**E-54 Regional Lift Station - RFCSP
Solicitation Number: CO-00537
Job No.: 22-2502**

**ADDENDUM 2
October 25, 2022**

SAWS JOB NO. 22-2502
JOB NO. 11500-51
DATE: SEPTEMBER 2022
DESIGNER: RM
CHECKED: DRAWN
SHEET: C3.00

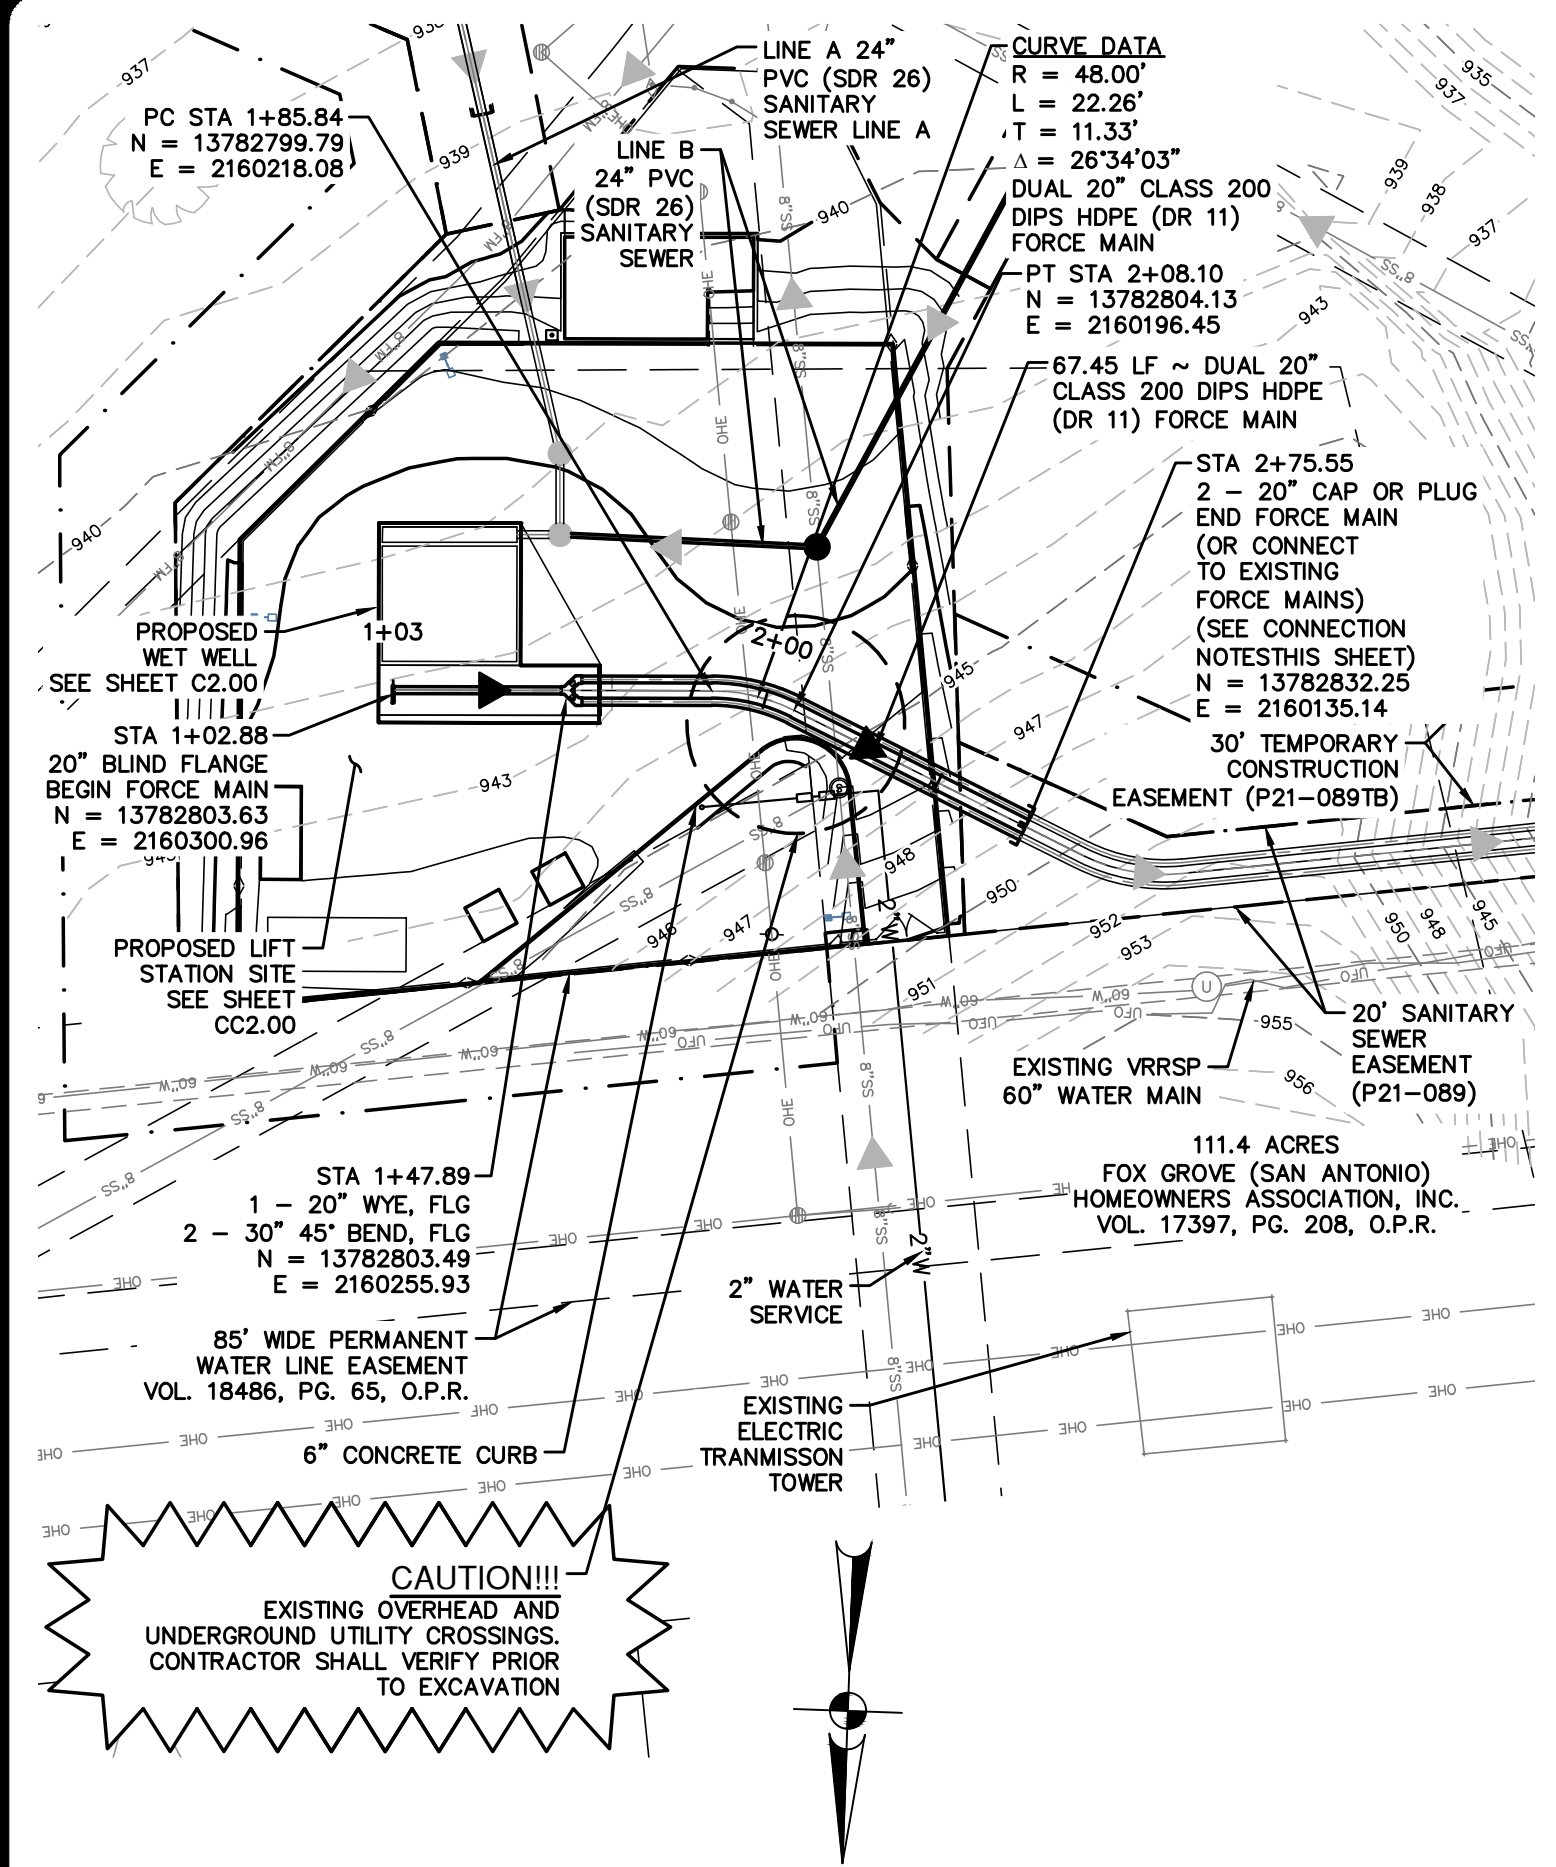
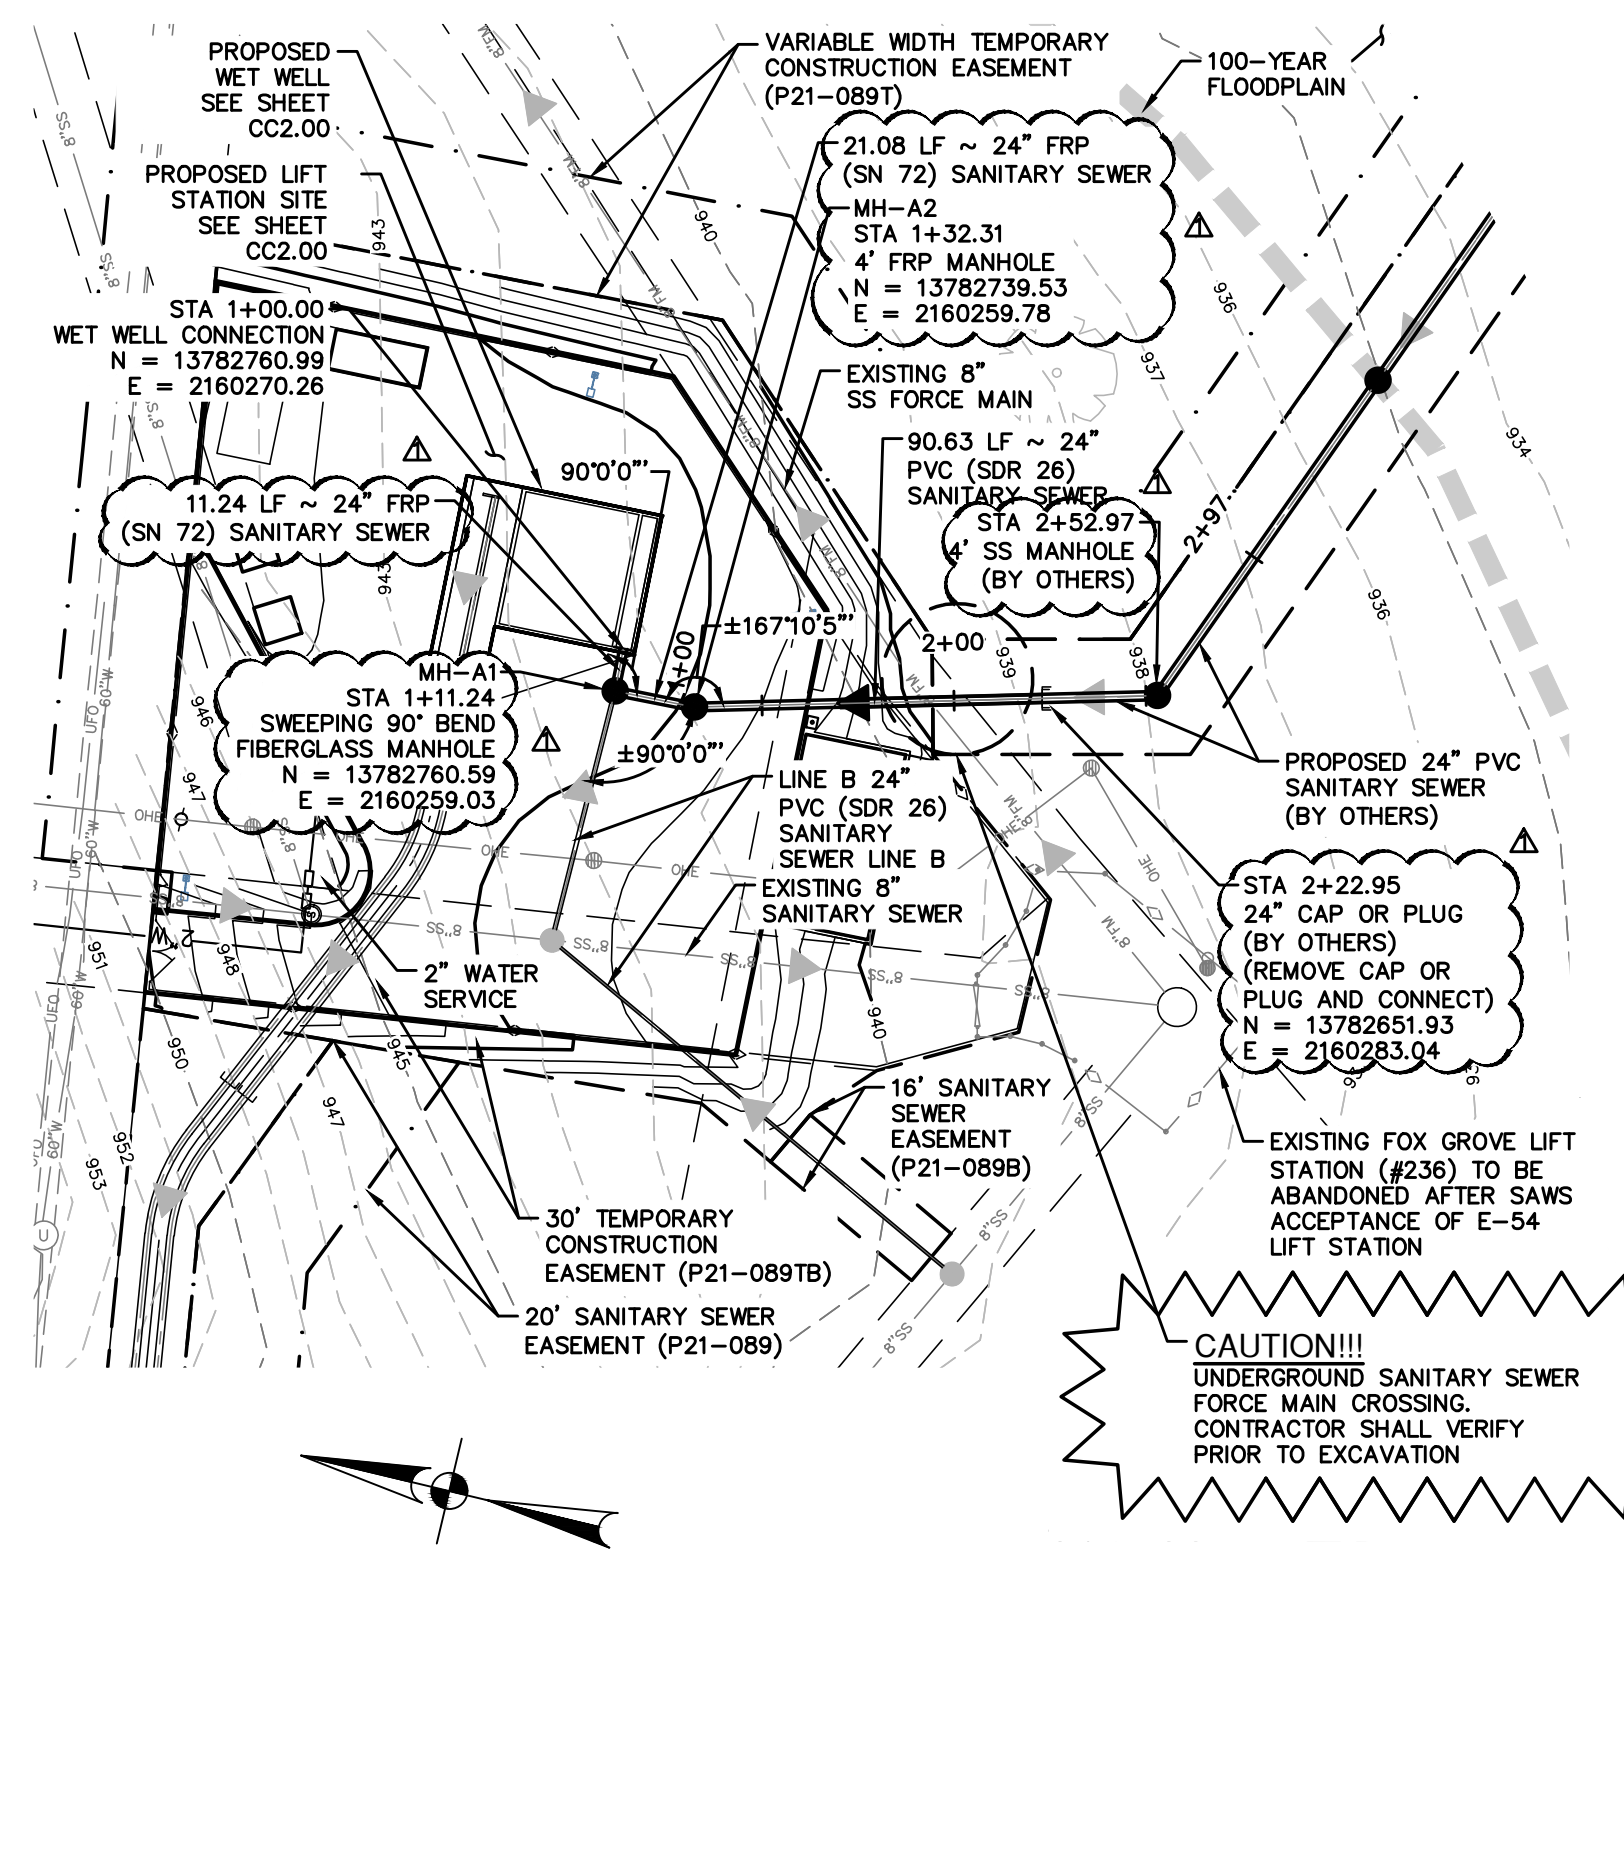
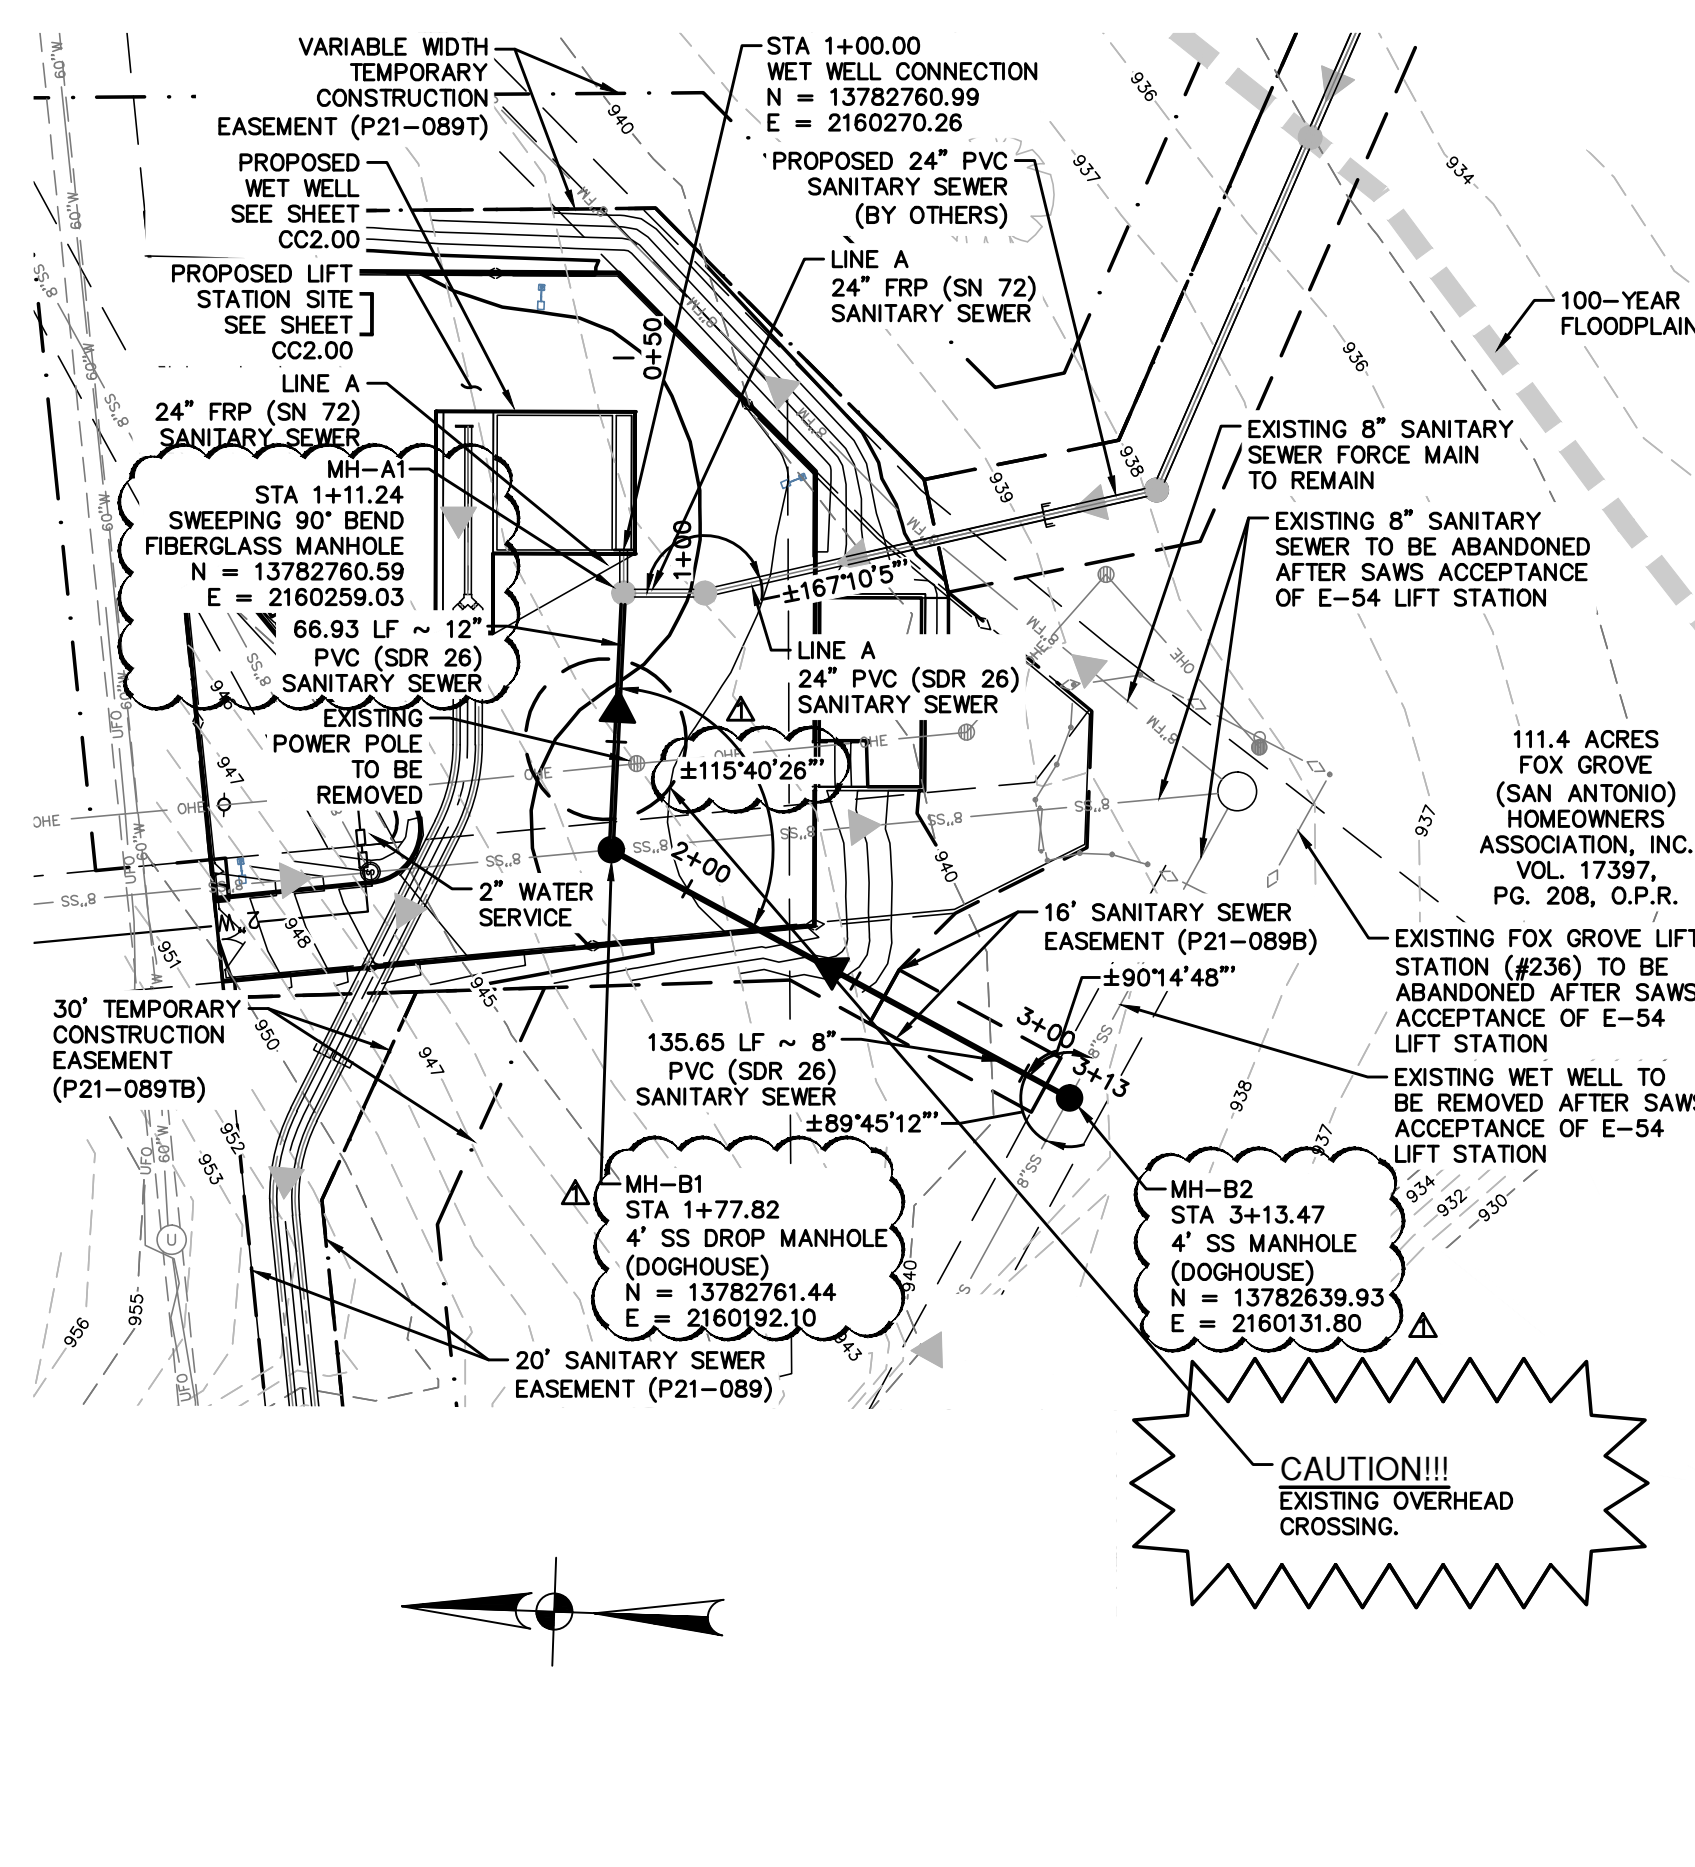
There are discrepancies between dimensions of Sheet E4.00 as compared to E10.00 as well as other electrical building plans. When scaling the foundation of the electrical building on E4.00, it gives a dimension of 32'x14'. Using the scale provided on E10.10 through E10.20 the foundations show to be 37'8"x15'8", same as shown for architectural plans. Site dimensional control Sheet C2.01 seem to indicate the building foundation is 32'x14'. Same goes for other structures on site having different dimensions between site dimensional control plan and individual structural plans. Please clarify which scales are to be utilized.

RESPONSE: Sheet C2.00, C2.01, Sheet C3.00, and E4.00 are revised to show correct interior electrical building and wetwell dimensions and dimensional controls of 36'x14' and interior wetwell dimensions of 35'x35', respectively. Contractor shall refer to structural drawings for foundation perimeter dimensions for these structures. See Changes to the Plans #1, #2, #3, and #9.
